Product Change Notification

Product Change Notification: P-25-028147

Multigig RT2, RT2-R, RT3 Daughtercard connectors with Differential wafers

wafer comparison

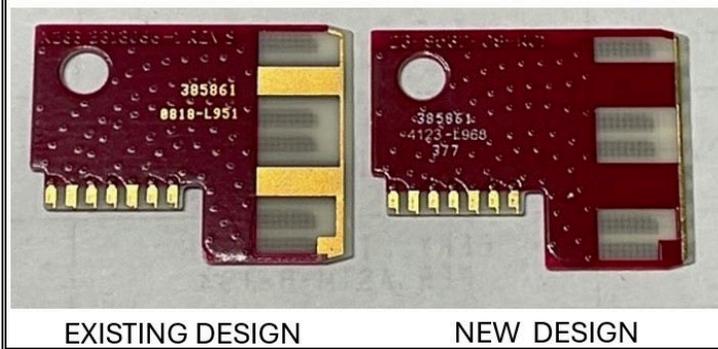
Current Differential Signal wafers have Gold plated ground pads strategically located on non-contact areas of the backside of the wafer. These pads are used for Impedance tuning of the Differential signal pairs on the opposite mating side of the wafer. The Gold and Nickel underplate over the Copper Ground pads will be replaced by extending the existing soldermask material to cover the non-contact areas. See attached photo. Samples have been tested both electrically and mechanically to verify they continue to meet the same performance and are compliant to the TE Product Specification.

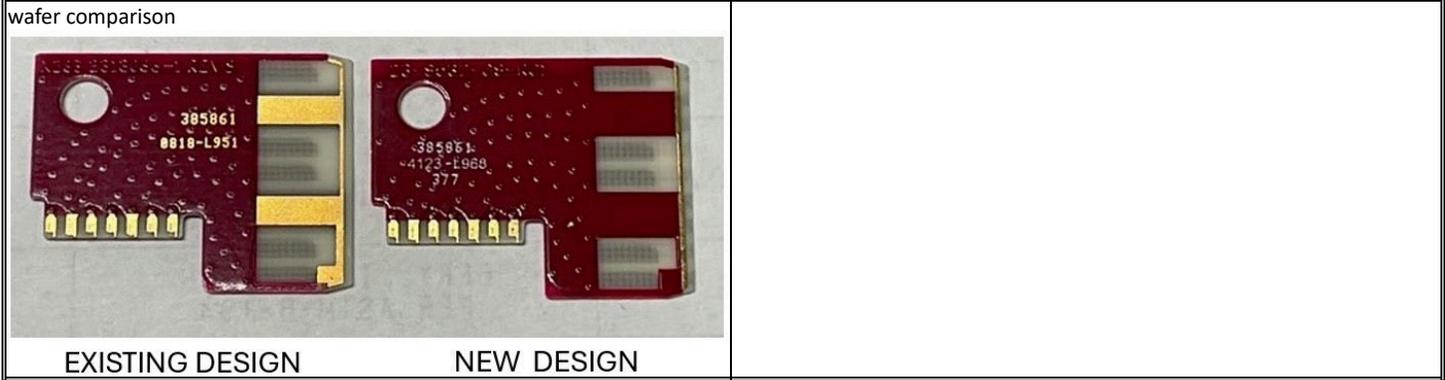
Description of Changes
Current Differential Signal wafers have Gold plated ground pads strategically located on non-contact areas of the backside of the wafer. These pads are used for Impedance tuning of the Differential signal pairs on the opposite mating side of the wafer. The Gold and Nickel underplate over the Copper Ground pads will be replaced by extending the existing soldermask material to cover the non-contact areas. See attached photo. Samples have been tested both electrically and mechanically to verify they continue to meet the same performance and are compliant to the TE Product Specification.
